Engineering Bulletin: ECR00175

Subject: **New Thermal Pressure Plate**

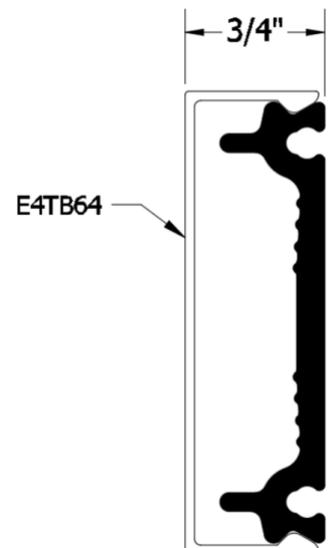
Tubelite introduces a new thermal pressure plate for use on all curtain wall systems with a 2-1/2" sightline. The new **Thermal Pressure Plate** employs the following features and benefits:

- The same 8" O.C. screw spacing as on our standard aluminum pressure plates
- With a comparable thickness as the aluminum pressure plates, the same fastener can be used with no flat washers required
- ID's built into the face for location of weep holes for the system used
- Standard isolators are used for the 400CW and 400T systems and a continuous seal for the 400TU and 400SS systems in lieu of an isolator
- The new **Thermal Pressure Plate** matches the strength of aluminum and exceeds that of our polyamide pressure plate while offering comparable thermal performance at the same price point as polyamide
- All standard 400 Series face covers are interchangeable with the new PTB120 pressure plate (E4TB64 shown below)

The new **Thermal Pressure Plate** is part number PTB120. Updates to the Price Book, Installation Manuals and Perimeter Sheet details are available now.
